# Management and Staff Review And Recommendations

Renovation/Expansion Studies  
1995-2008

# Concourses

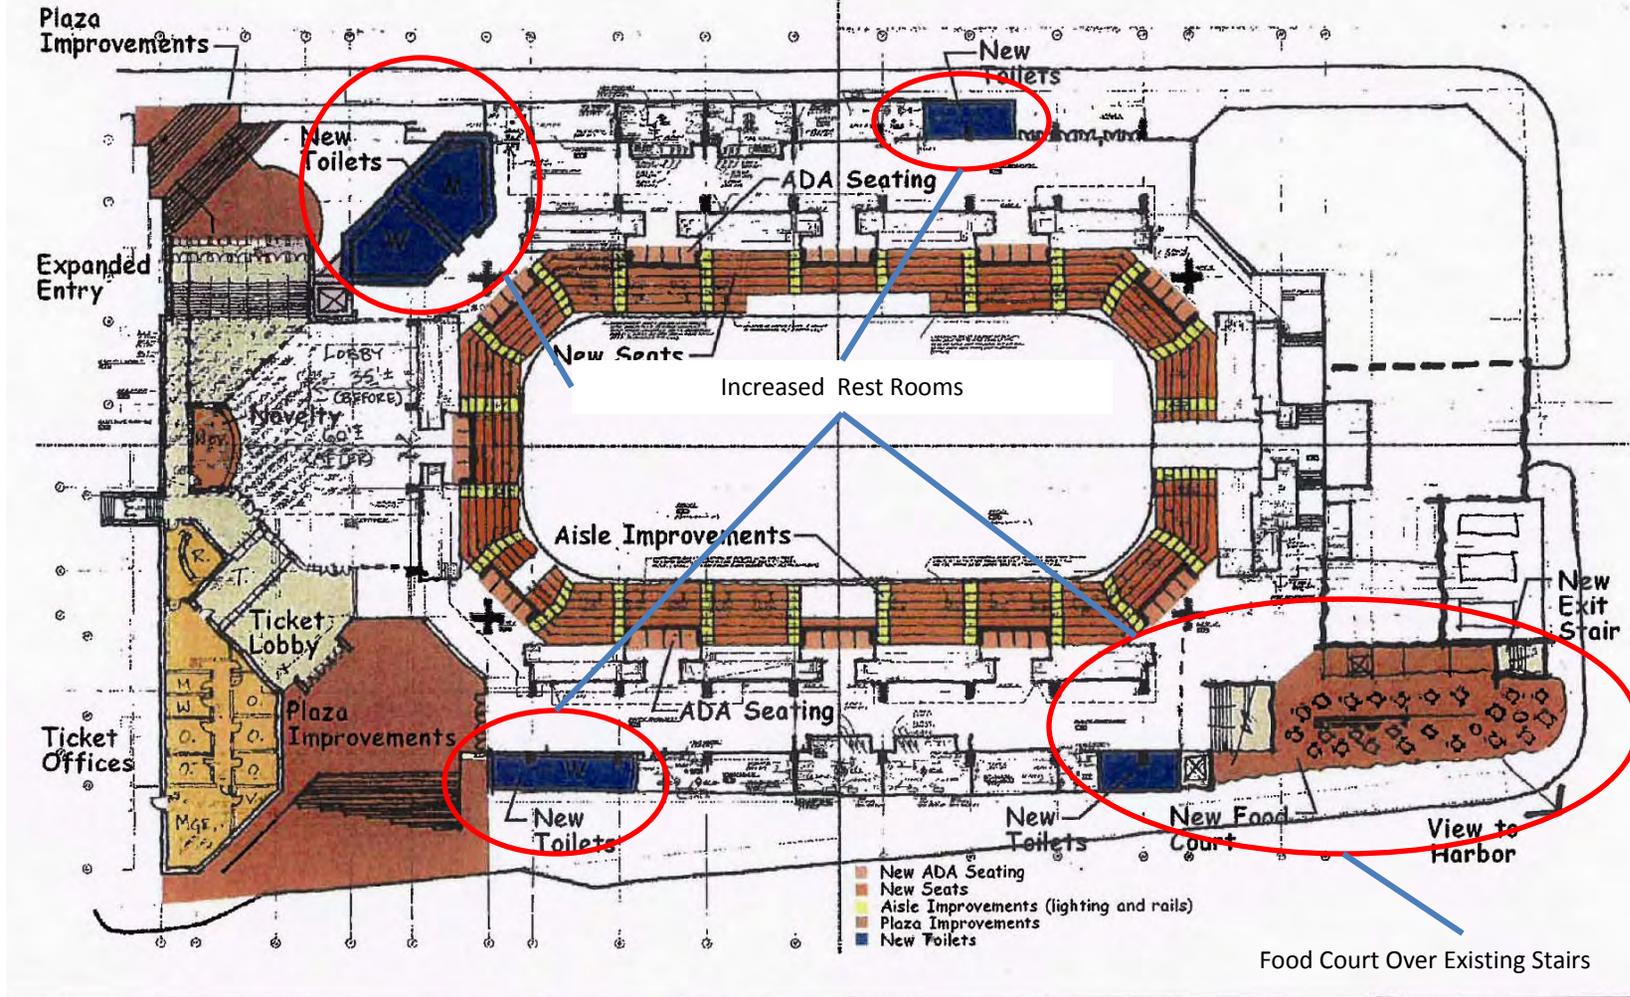
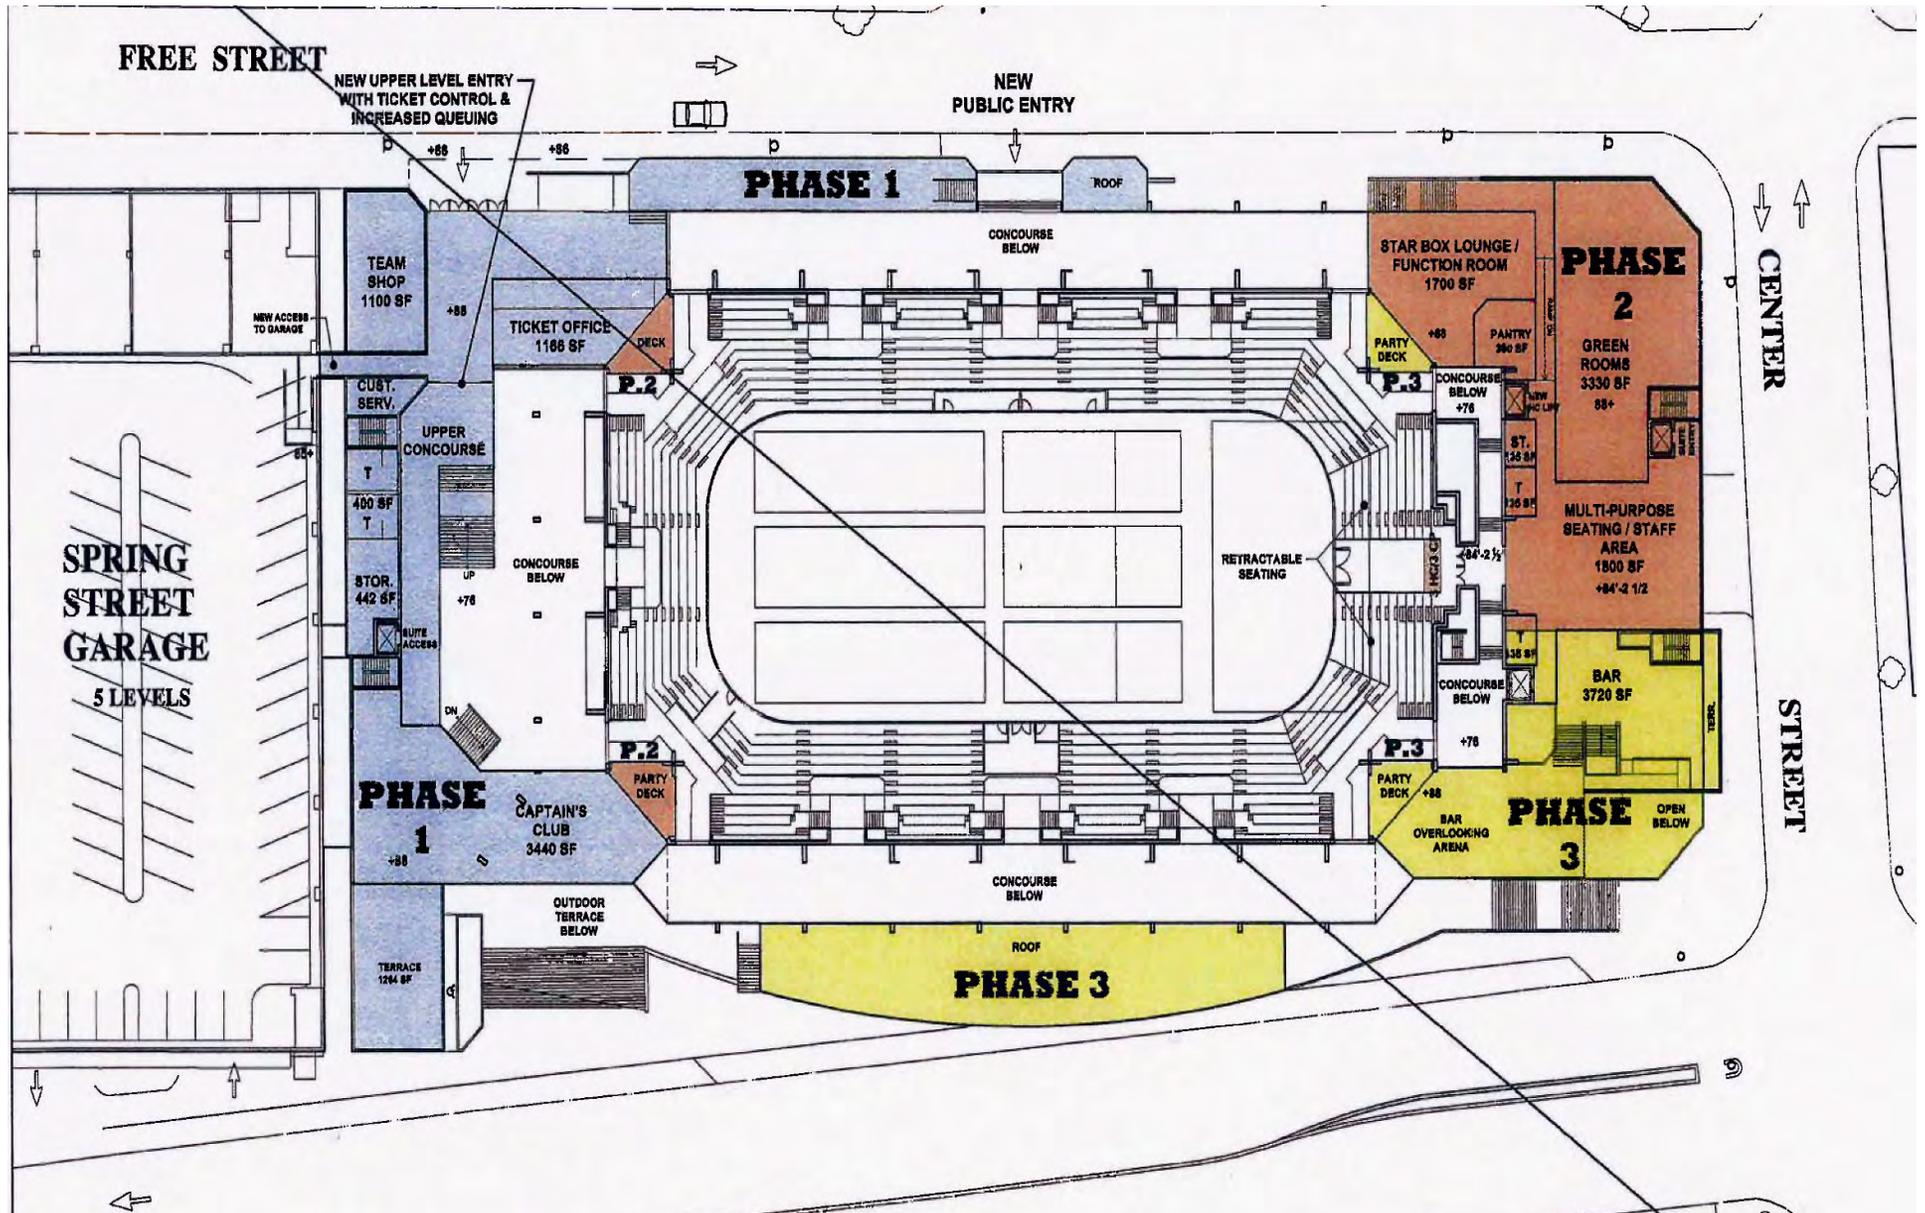
- Streuever is the only one to propose widened concourses. Widened concourses allow for increased concession space and restrooms.
- Both Heery and Streuever add a food court concept. Integration of both designs and a redesign will increase usable space.

O'Dell Study

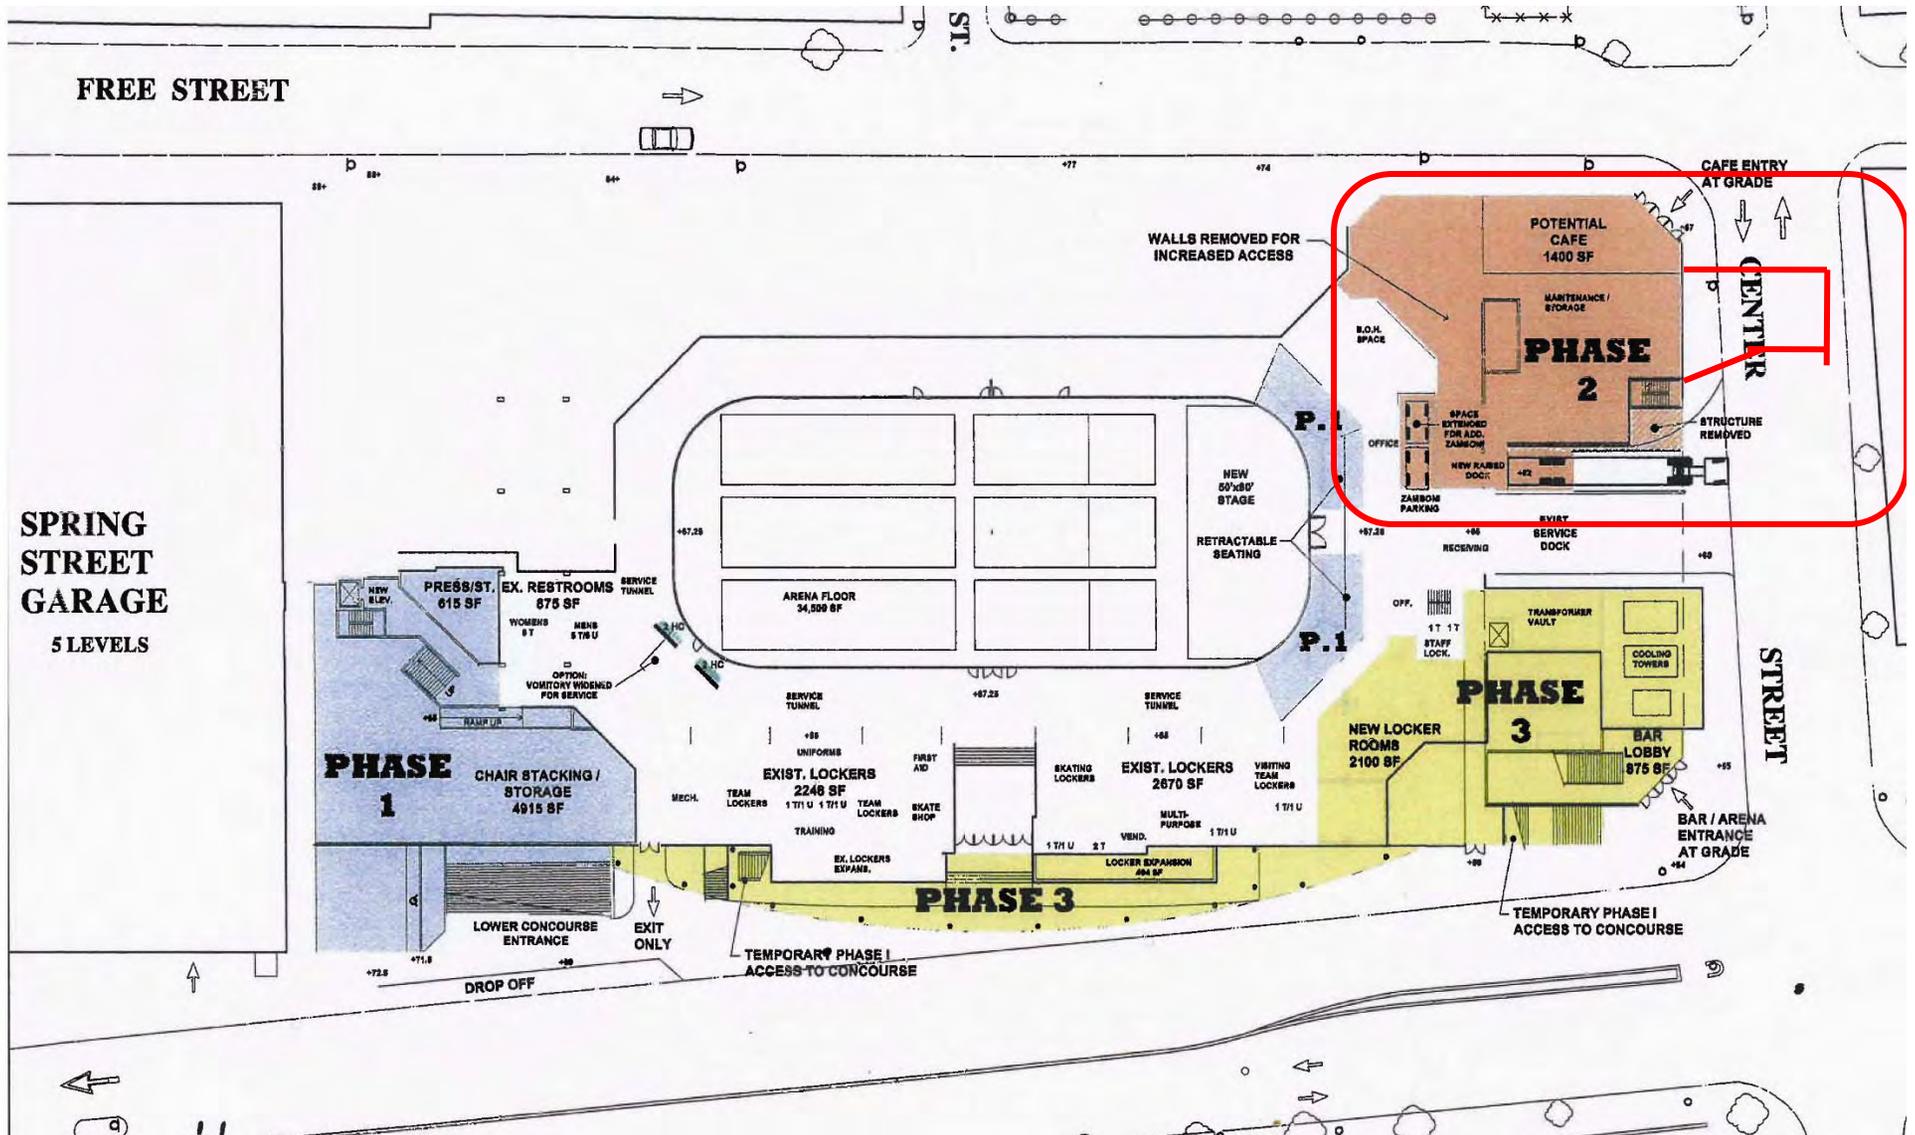
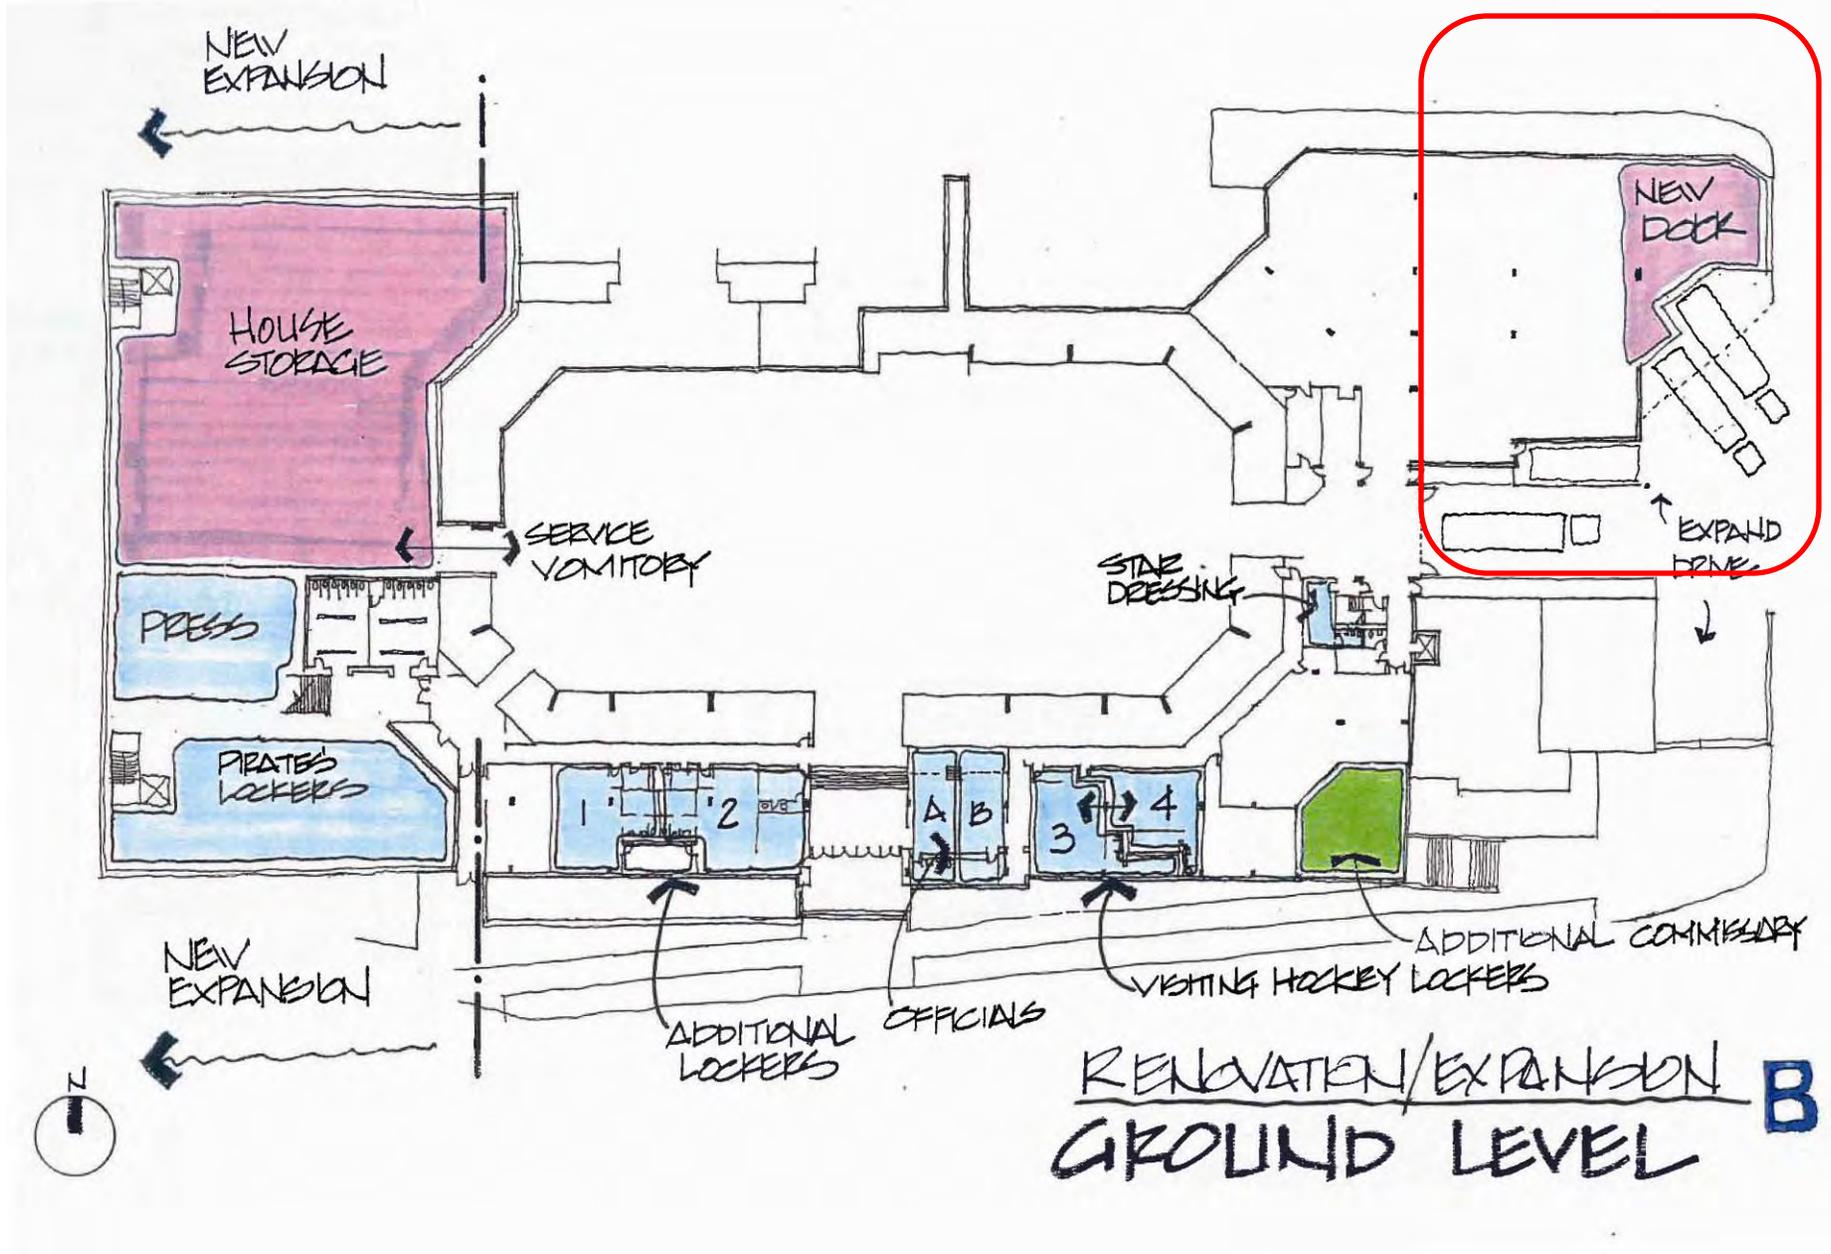
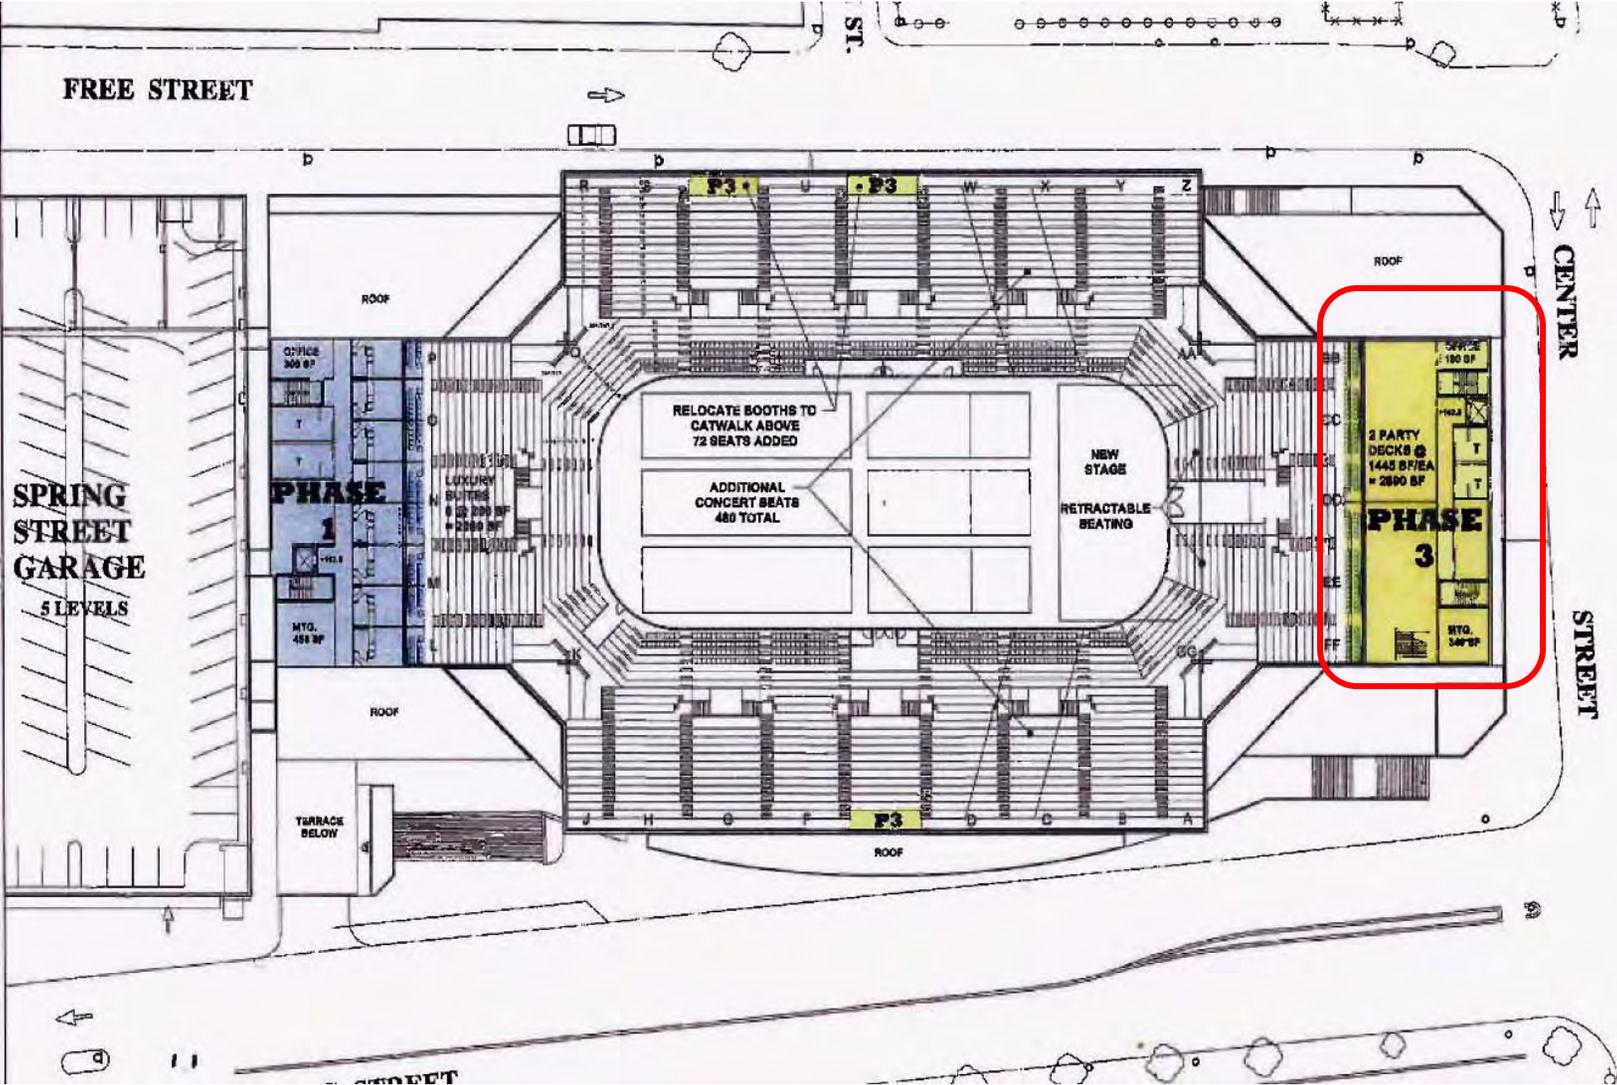
- O'Dell proposed the most viable loading dock scenario. We feel this design should be used as a base but the area should be extended into Center Street.

- Heery proposed a food court extending over the current Center Street end stairs. Streuever also proposes a food court on that end of the building. The Steuever plan calls for a ground up build with multi-level bars. We feel that a concourse level food court as proposed by Heery is optimal if it could be married with the Streuever Bros. proposal for the Free Street side of the loading dock. Ideally, all the amenities on the Center Street end should be Connected on the upper concourse level and self contained creating a small, "sub-venue" that can be used for events while the arena is being used or opened early without interfering with pre event operations. This area would be ideal for a "closed" backstage area during shows. This would need to incorporate Green rooms, kitchen, restrooms and function space to be ideal.

- Steuever Bros. Did a great job adding square footage, but we feel that this additional space should be more functional for events other than hockey. Changing how the space is allocated will accomplish this.

- We feel that the Starbox Lounge proposed by Steuever Bros. on the upper concourse level is a good concept but again it should be easily integrated with the greenroom/dressing room space and be able to be self contained for non-hockey events.

- The party suites proposed by Steuever Bros. is unnecessary and we feel the costs to develop this space could be diverted to other areas to keep the project costs down.
